# ***PLANT BARRY HYDROGEOLOGIC CONDITIONS SUMMARY***

Plant  
Barry  
Ash  
Pond

# Local and Regional Reaction to Plant Barry Coal Ash Pond Closure Plan

# Hydrogeologic Cross Section

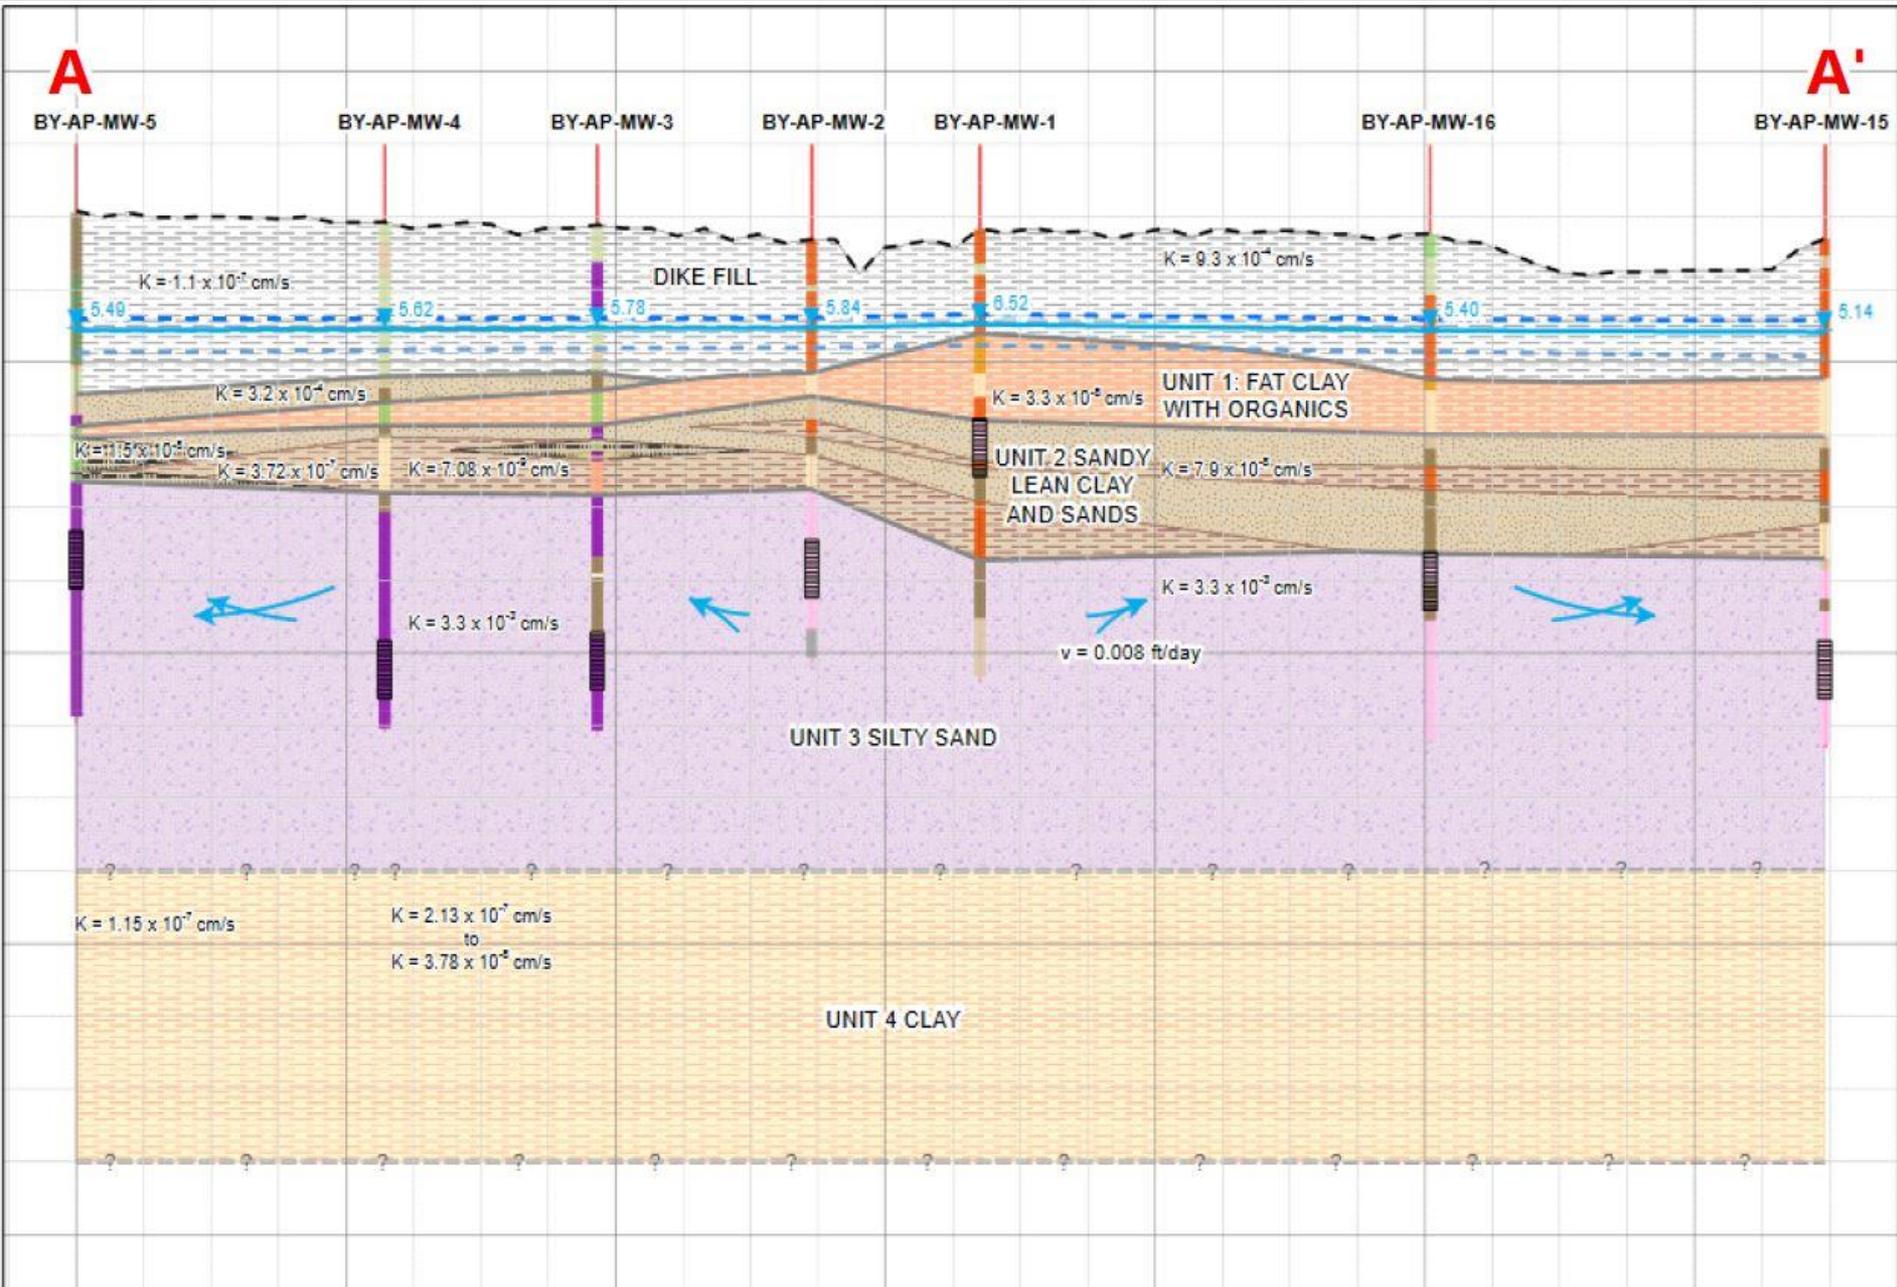
Are the clay layers underlying the ash pond homogeneous, impervious, and continuous?

No. The clay layers are not homogeneous. There are massive clay layers, but in some areas the unit contains silt and fine-grained sand.

The clay unit is continuous but varies in thickness from 4 to 28 feet and is lithologically variable.

Conclusion: The clay unit is an effective aquiclude.

January 2018  
Potentiometric Surface Map

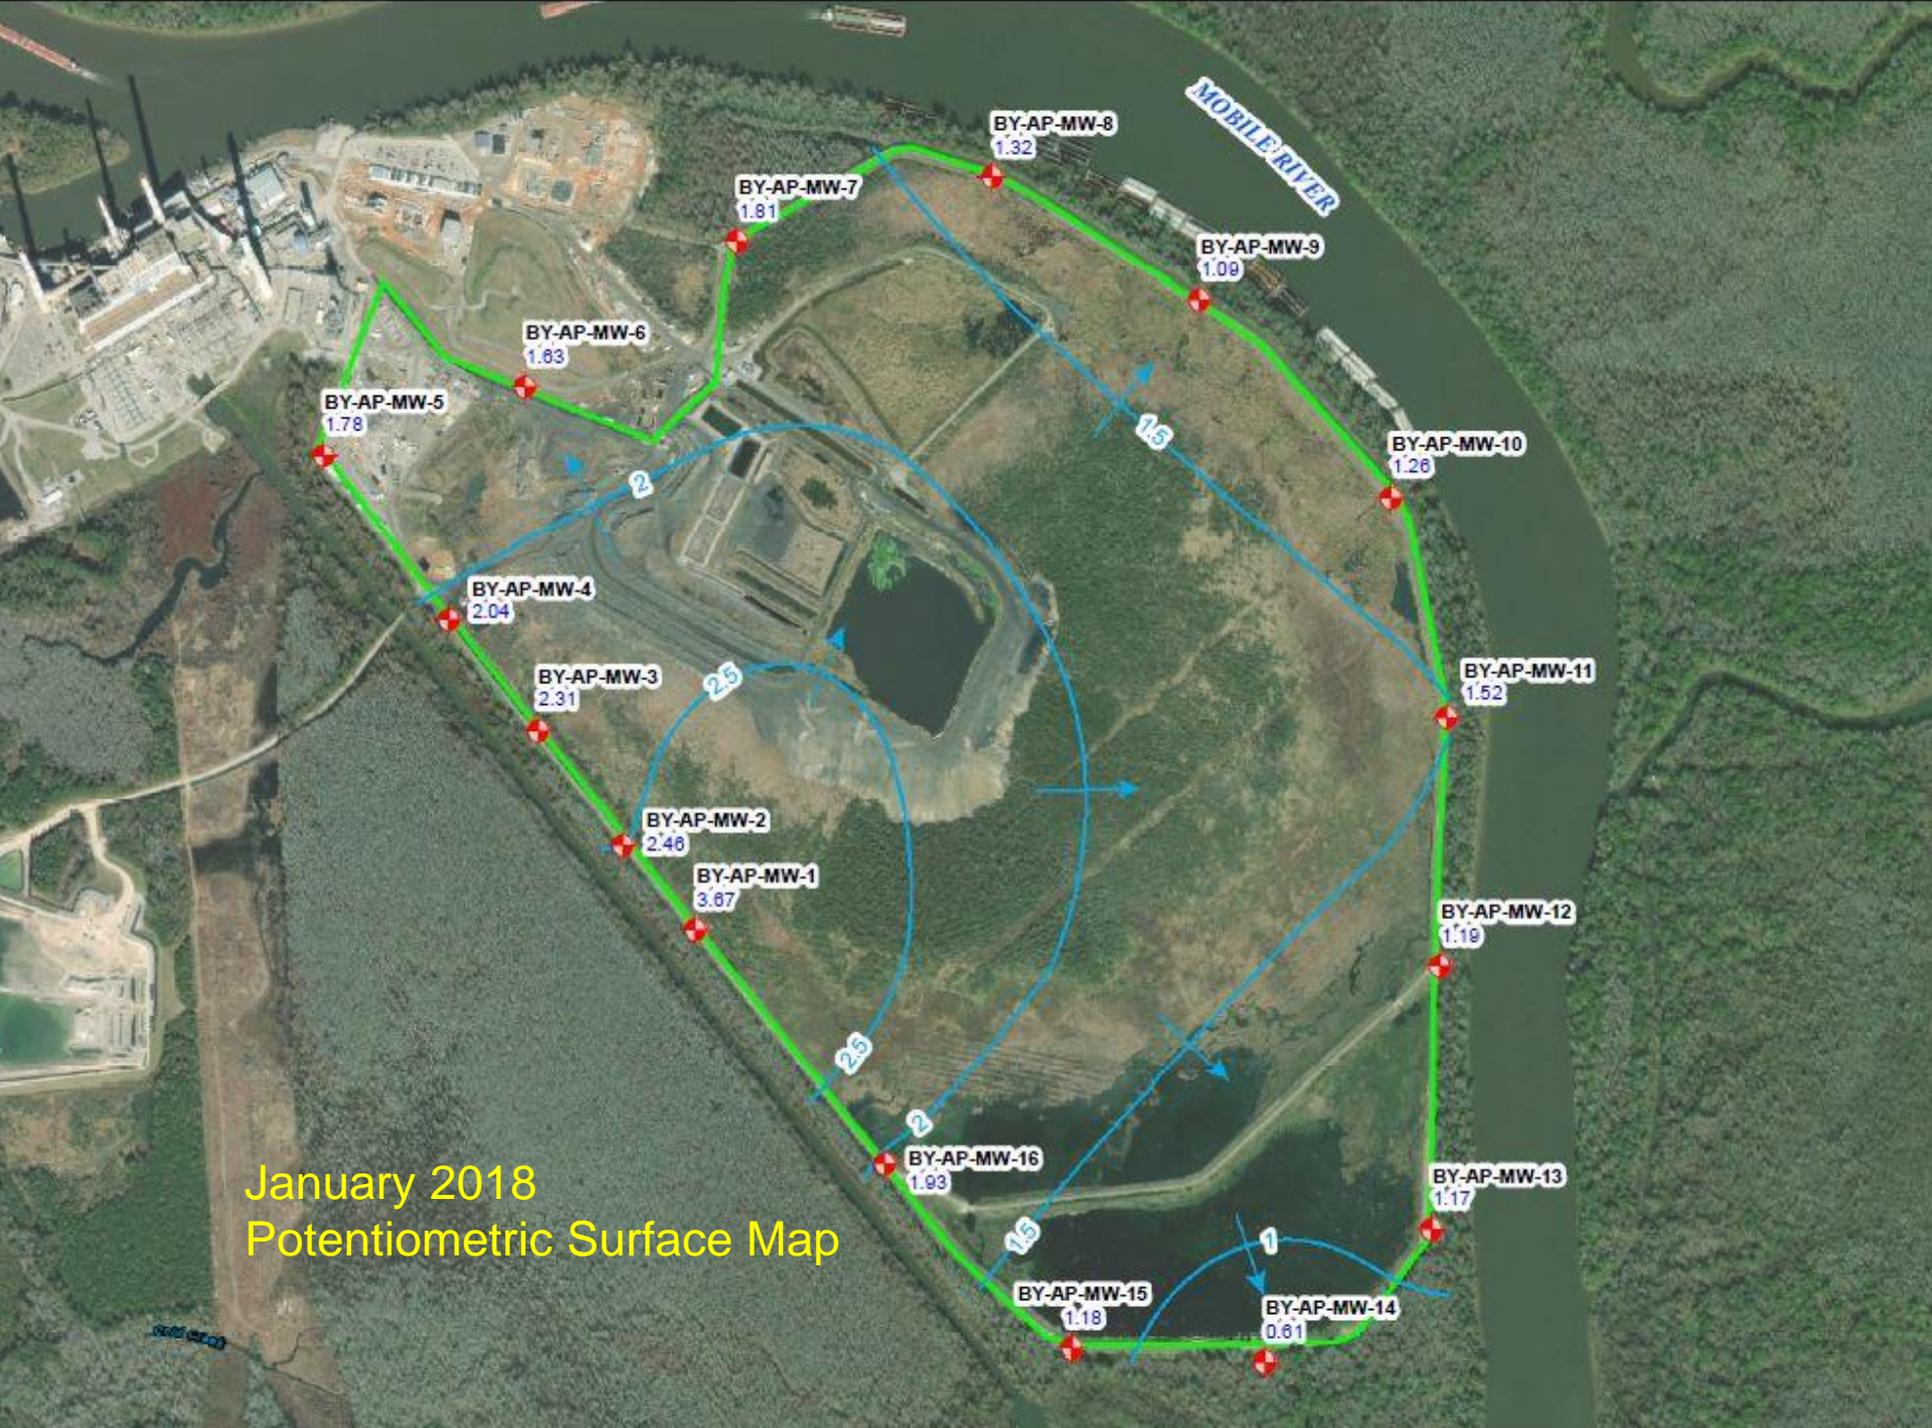
Is the alluvial aquifer, underlying the ash pond confined?

The Mobile Baykeeper report (section 4.3) states *“In the vicinity of the ash pond, there are two major aquifers, the alluvial coastal aquifer, which is of Holocene age, and the Miocene and Pleistocene aquifer. These aquifers are regionally important as they are unconfined, which means groundwater is in direct contact with the atmosphere through open pore spaces of soil or rock. They are considered to be highly susceptible to contamination because they are hydraulically connected to surface water and each other.”*

All 16 monitoring wells constructed in the alluvial aquifer have positive hydraulic heads from 13.97 to 55.7 feet.

Conclusion: Clay layers underlying the ash pond form an effective confining unit.

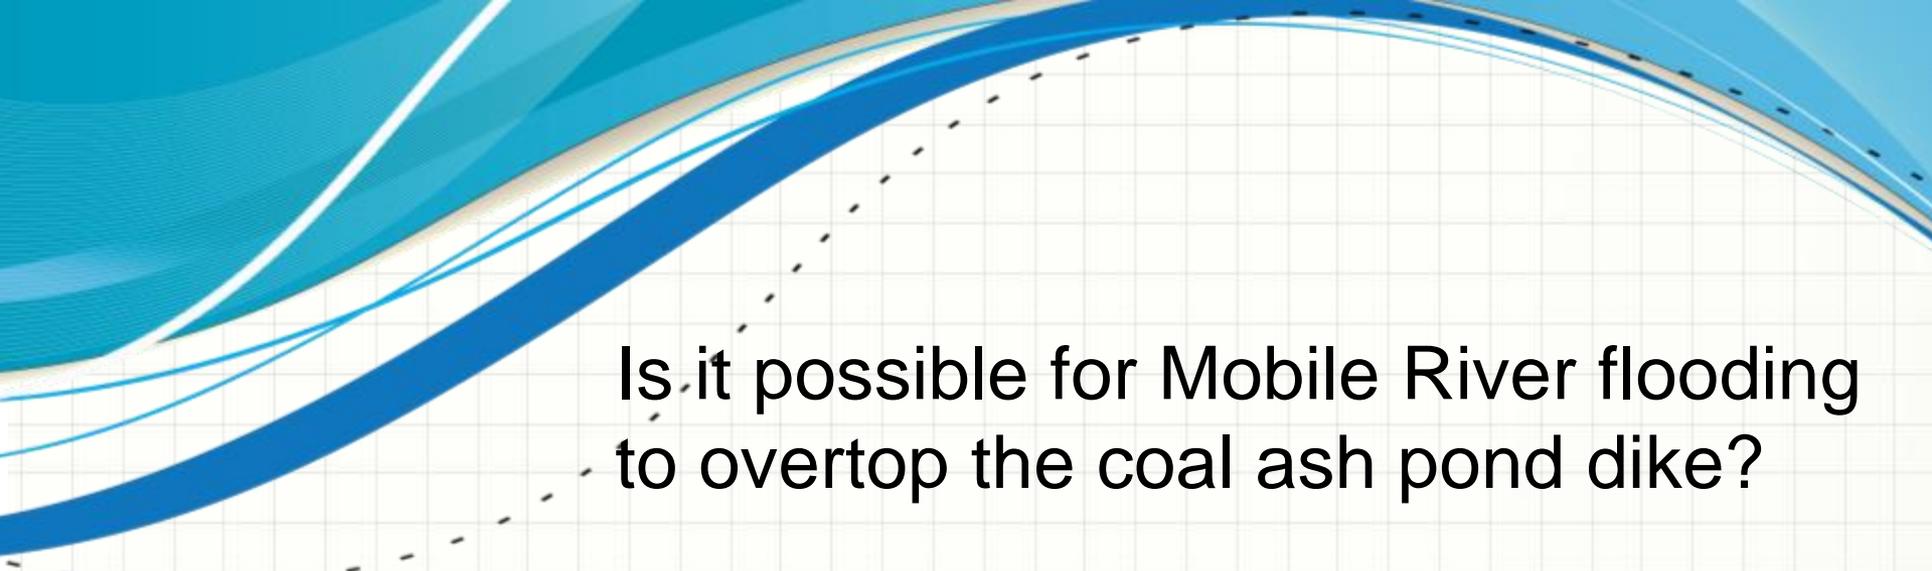
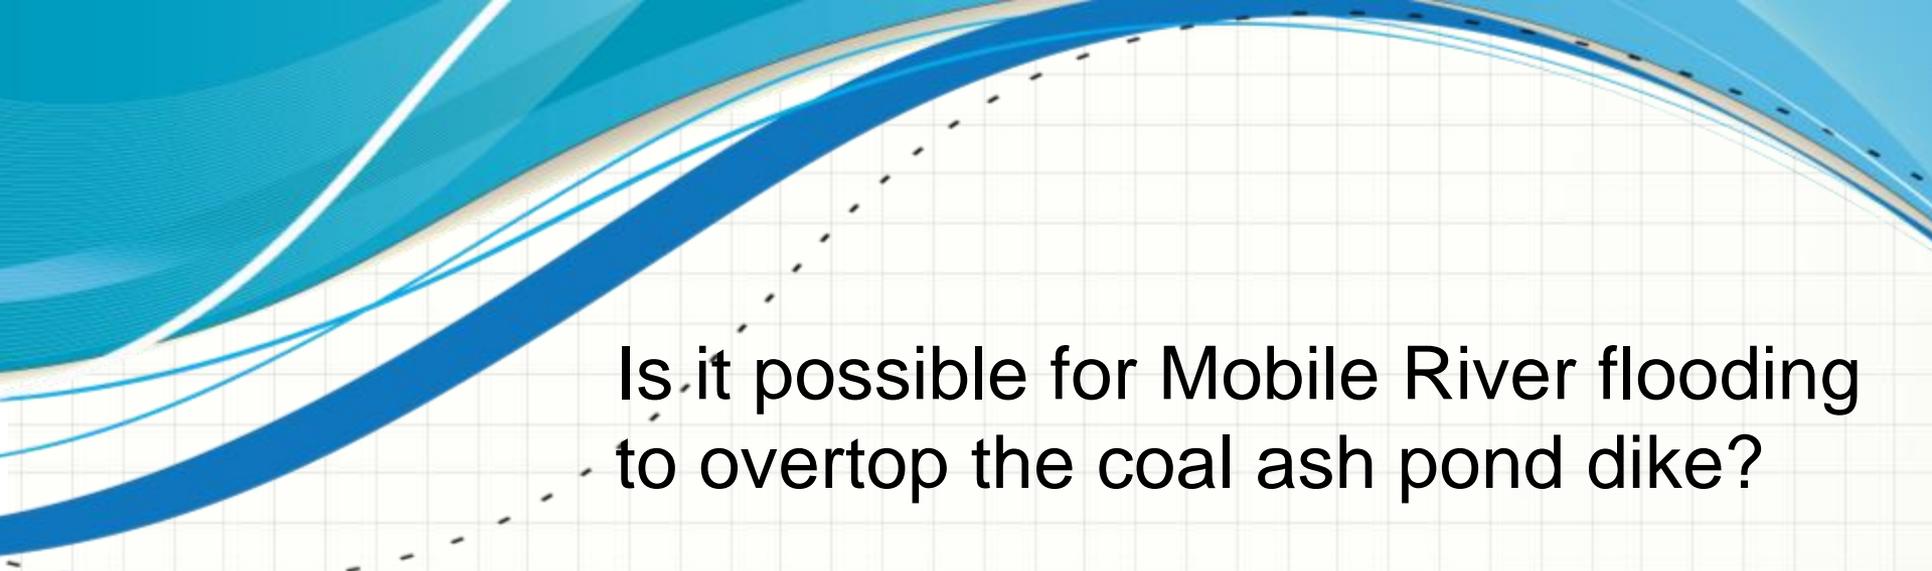
## Is it possible for Mobile River flooding to overtop the coal ash pond dike?

Combinations of future climate factors, including rising sea level, a major upstream flood, and a severe tropical storm could cause a catastrophic flood event on the Mobile River that could result in erosion of the coal ash.

Conclusion: A catastrophic level flood event on the Mobile River at the coal ash pond site has not been simulated. Whether the coal ash is excavated and relocated or capped in place, the impacts of a flood of this magnitude during the next 20 to 30 years should be considered and impacts on an encapsulation structure for an indefinite time period should be a part of an in-place closure plan.

Cook Hydrogeology has recommended to Alabama Power on multiple occasions that simulations of various major flood scenarios is warranted.
